## NINE MILE POINT NUCLEAR STATION

**SUBJECT:** Nine Mile Point Nuclear Station  
Unit No. 1; Docket No. 50-220

Request to Utilize an Alternative to the Requirements of 10 CFR 50.55a(g) for the Repair of Control Rod Drive Housing Penetrations – Response to NRC Follow-up Request for Additional Information (TAC No. ME5789)

**NINE MILE POINT UNIT 1  
RESPONSE TO NRC FOLLOW-UP REQUEST FOR  
ADDITIONAL INFORMATION REGARDING  
10 CFR 50.55a REQUEST NUMBER 1ISI-004**

Figure 1 – Typical CRD Housing/Stub Tube Configuration

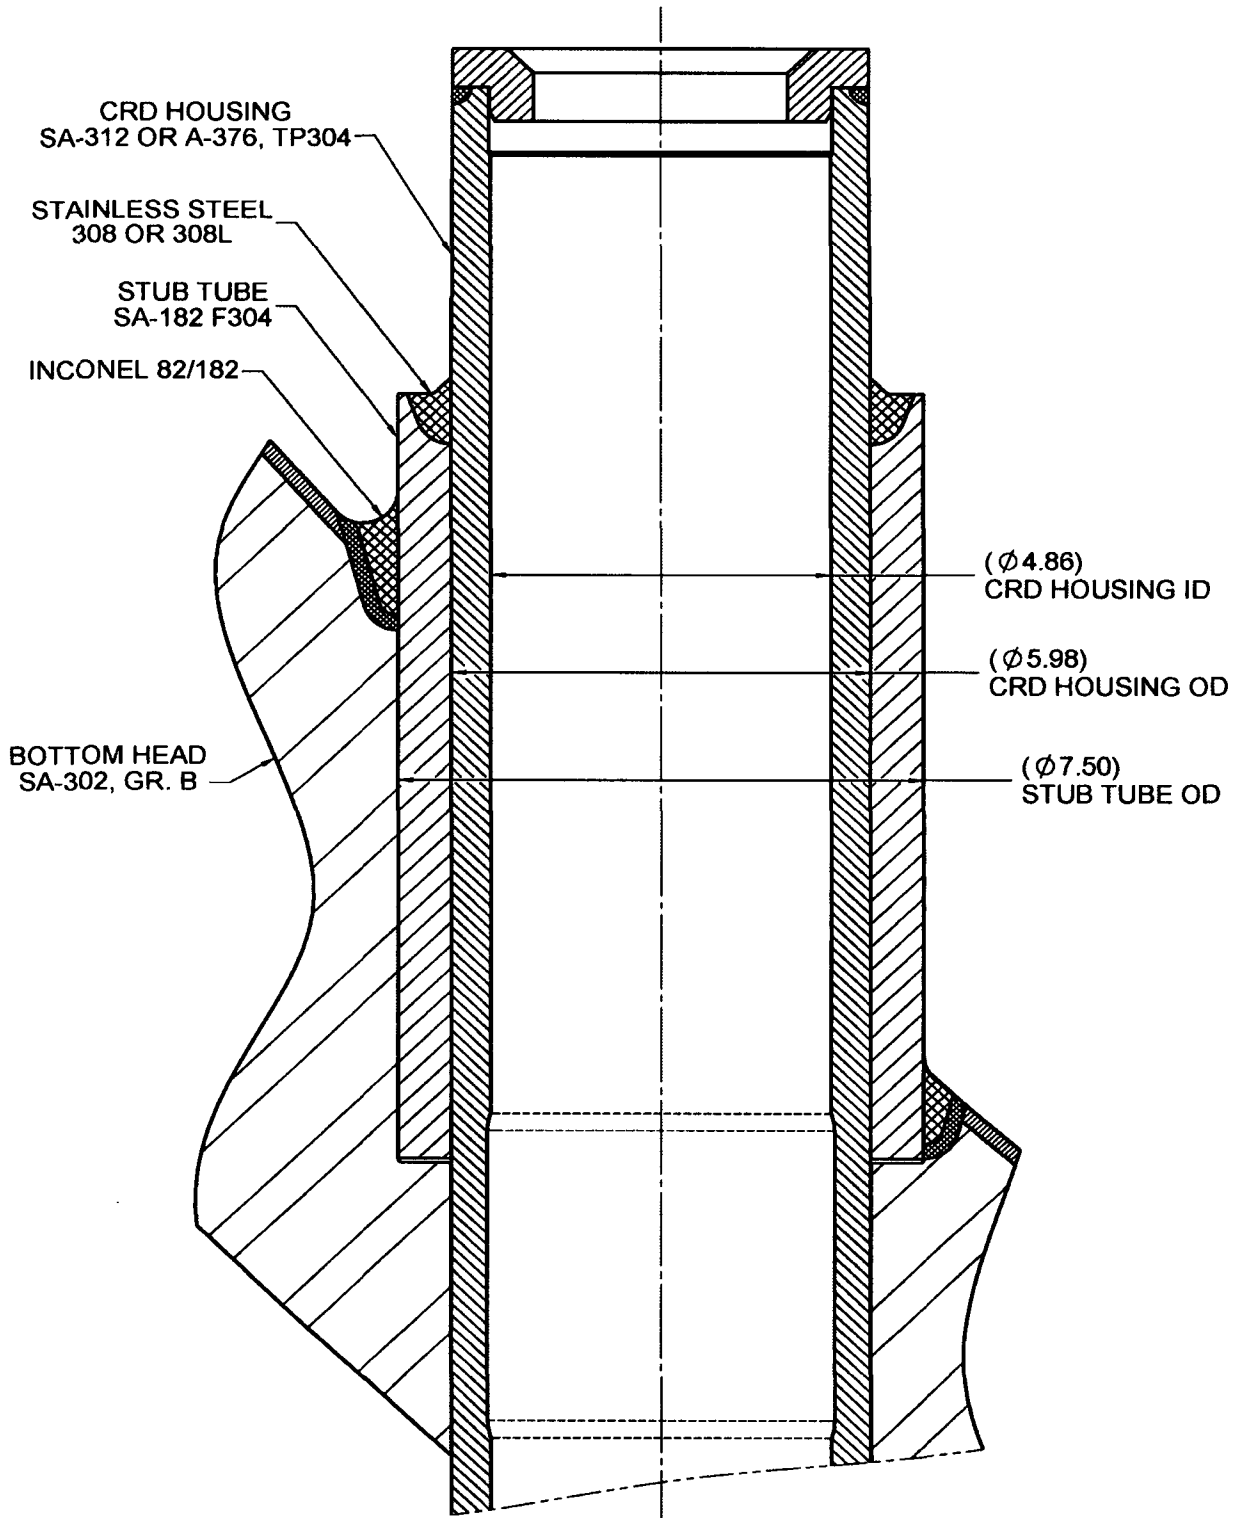
**Description:** Penetrations for the CRD housings are located in the lower head of the reactor vessel (RV). Stainless steel stub tubes are welded to the penetrations and CRD housings are welded to the stub tubes. The general configuration of the CRD housing penetrations is shown in Figure 1, and the component materials are summarized in Table 1.

Figure 2 – Modified CRD Housing

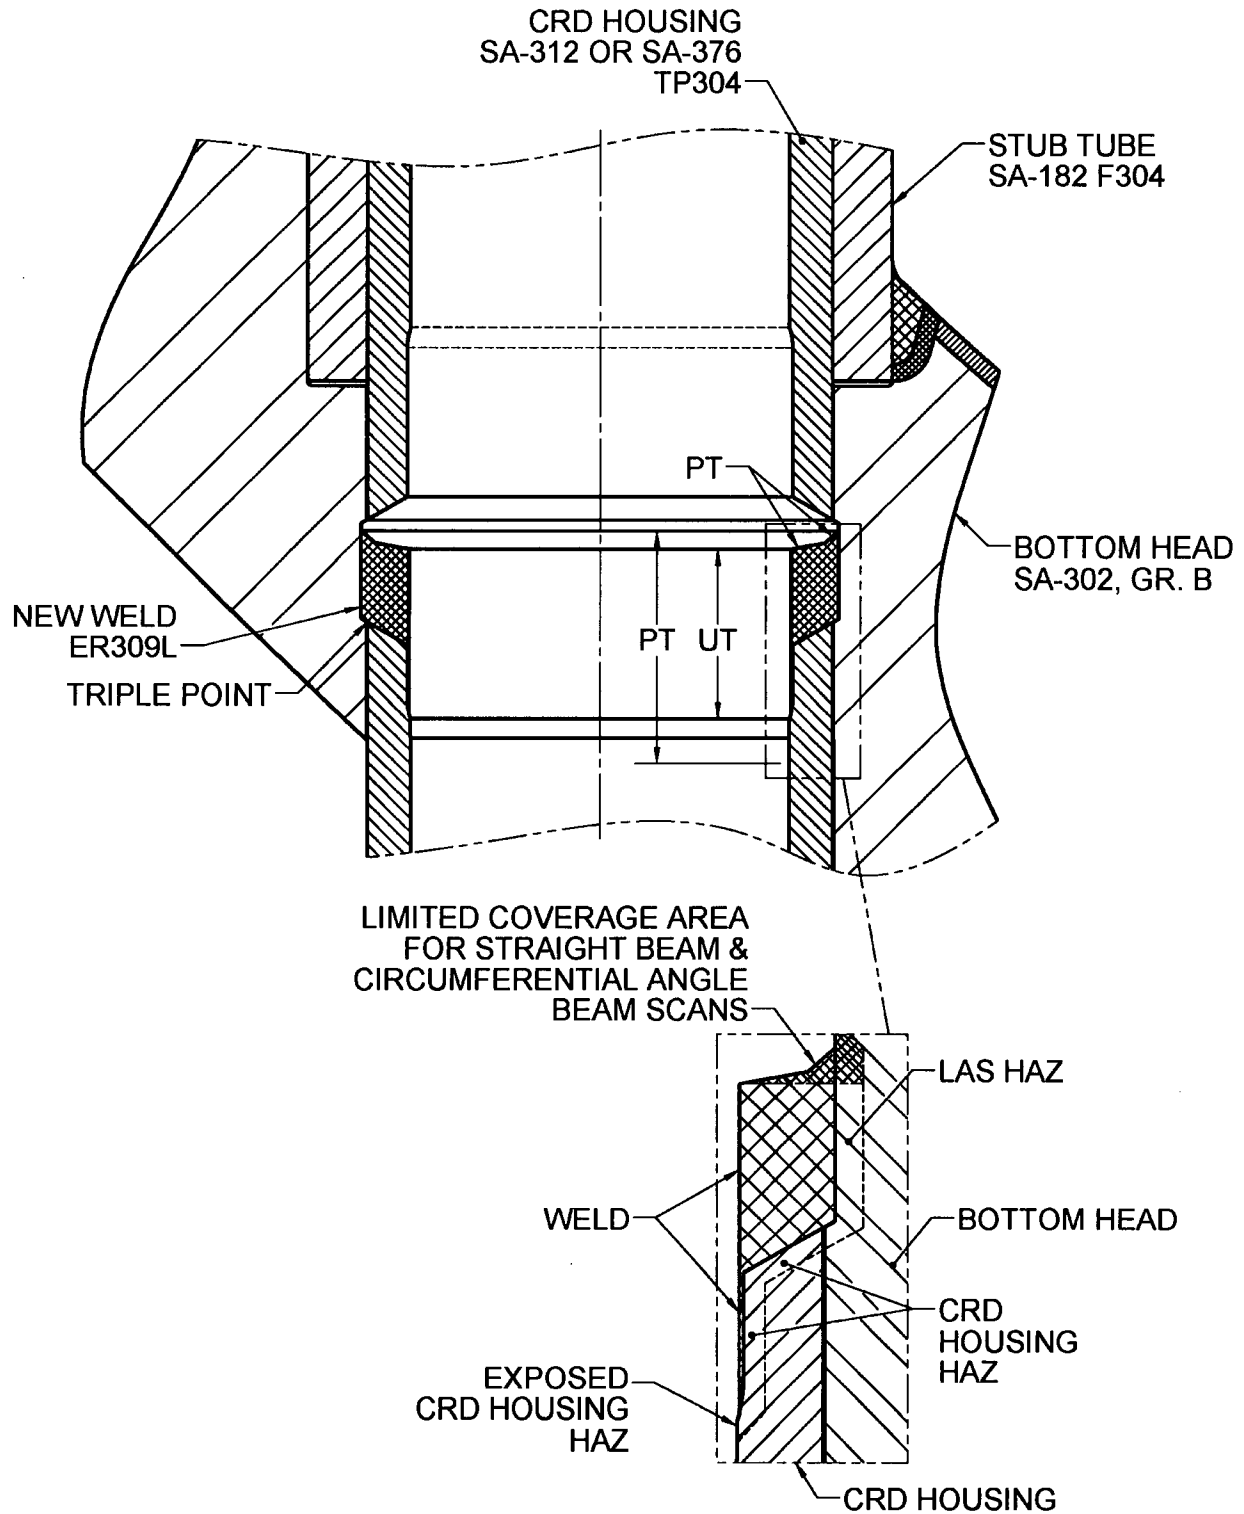
Roll expansion repair is the preferred strategy for the license renewal period to maintain zero leakage at CRD penetrations. However, the license renewal commitment also stated that during the period of extended operation, should a CRD housing penetration (stub tube) rolled in accordance with the provisions of the Case N-730 resume leaking, NMPNS will implement a zero leakage permanent repair prior to startup from the outage in which the leakage was detected. The permanent repair selected by NMPNS will consist of a variation of the welded repair geometry specified in BWRVIP-58-A (Reference 5) using Code Case N-606-1, as endorsed by the NRC in RG 1.147. The ambient temperature inside diameter temper bead (IDTB) welding method will be used to restore the pressure boundary of the CRD penetration(s). The IDTB welding method is performed with a remotely operated weld tool, utilizing the machine Gas Tungsten-Arc Welding (GTAW) process and ambient preheat temperature temper bead method with 50°F minimum preheat temperature and no post weld heat treatment. The repair will be conducted in accordance with ASME Section XI, 2004 Edition, no Addenda, Code Case N-606-1, and the alternative requirements discussed below. The repair will seal a leaking CRD housing penetration and provide a new reactor coolant system (RCS) pressure boundary weld, as shown in Figure 2.

Figure 2 depicts the areas for liquid penetrant (PT) examination and ultrasonic examination (UT) of the modified CRD penetration.

NMPNS requests relief from examination of the area defined in Code Case N-606-1, Paragraph 4(a). In lieu of Code Case N-606-1 Paragraph 4(a), final examination of the new weld and immediate surrounding area within the bore will be performed. The nondestructive examination (NDE) volumes and areas will be similar to those described in BWRVIP-58-A, as discussed in Attachment 2.
